DISCUSSION ON THE LHC PHASE 1 COLLIMATOR => RF question (06/10/2010)

Elias Métral and Ahmed Cherif

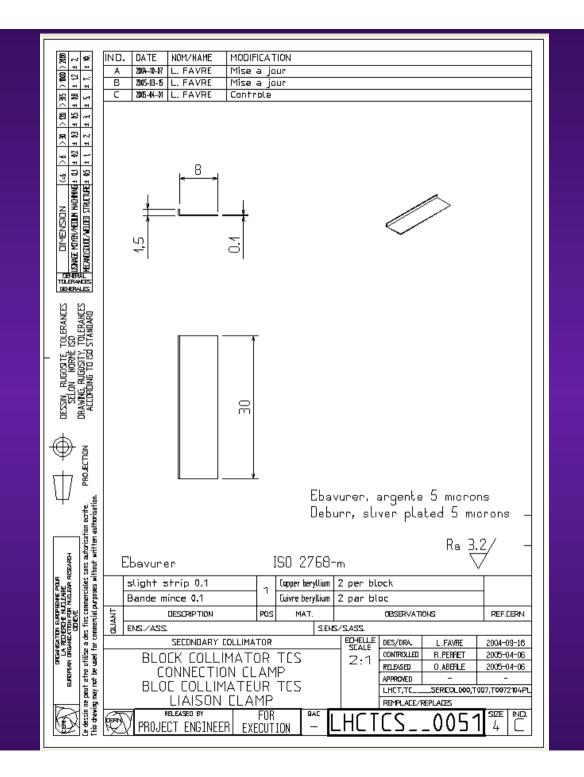
- Question: Should we add a "Liaison clamp" (see drawing LHCTCS__0051 in the following drawings) at the place indicated by the red arrows?
- Answer: No, as it is the same piece of equipment (which is in Glidcop, i.e. an alloy of Cu and Al). Note that in the other case indicated by the blue arrow a "Liaison clamp" is need as there is a gap between 2 pieces
